From: David Sagstad <david.sagstad@devplanning.co.uk>
Sent: 25 November 2021 14:33
To: Claudia Currie
Cc: Matthew Phillips; Jennifer Wagstaff; Nick Bateman
Subject: Nine Acres School - Residual Highways Queries, Formal Response
Attachments: Report-2004600WR1011.pdf; DPL SK011.pdf; DPL SK012.pdf

WESTMINSTER DRIVE/ PARK AVENUE

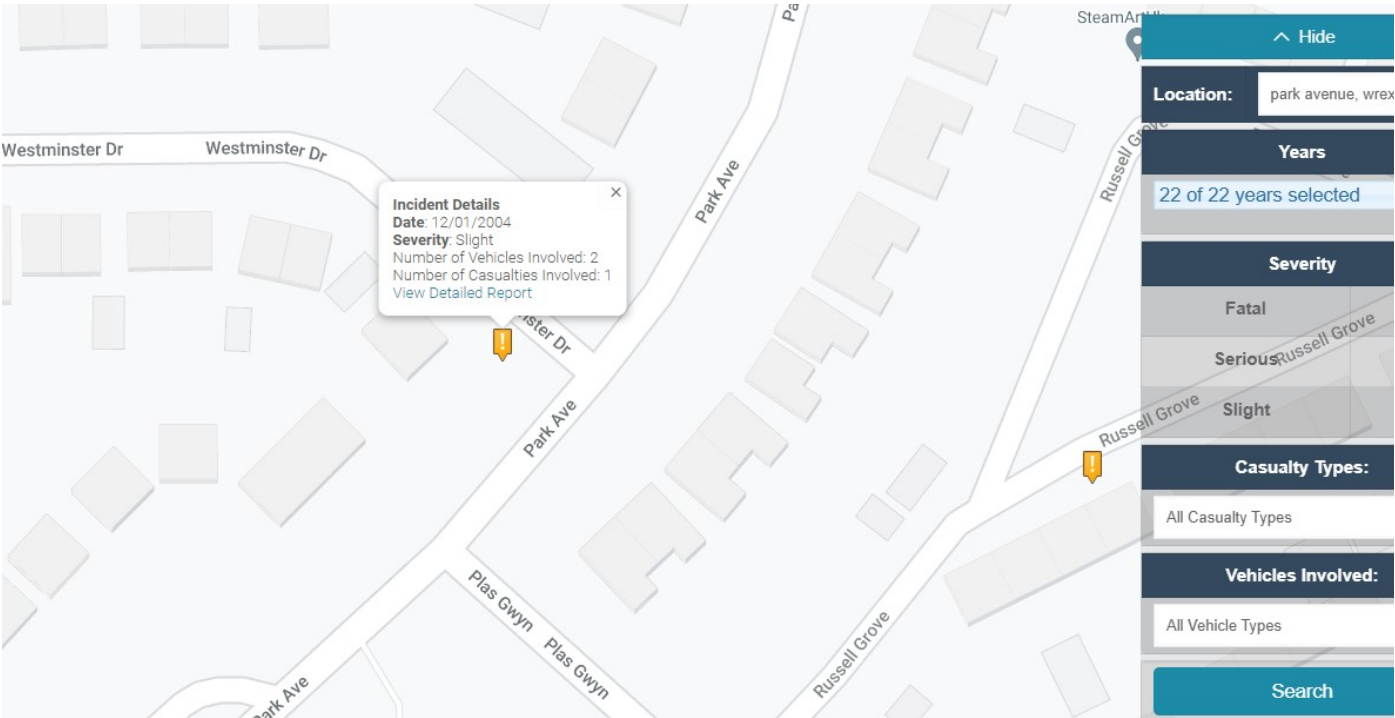
For the situation where the junction is utilised, it is important to firstly consider the accident records at the junction. We have utilised the national Crashmap database for this and summarise the findings below.

By way of background, in the last 22 year’s of data for the junction, there has been one recorded slight accident. That occurred in 2004, with no other accidents in the 17 years since then. That is to say that despite the trees, every single vehicle that has used the junction in 17 years has done so without a reportable accident, i.e. over 6,000 consecutive days with no accidents at all recorded.

For the only accident that did occur I attach the accident report. The report states that the accident was slight and occurred between two cars, both turning left. The driver of the first car appears to be significantly under age and, therefore, would not have had a licence – the driver was in the band 11 to 15. The other driver was in the age band 16 to 20, so may/ may not have been of legal age. In either event, at least one driver did not have a licence. The accident is not one that appears to relate to the trees, rather the experience/ legal status of the driver.

There is no material accident history at the junction:
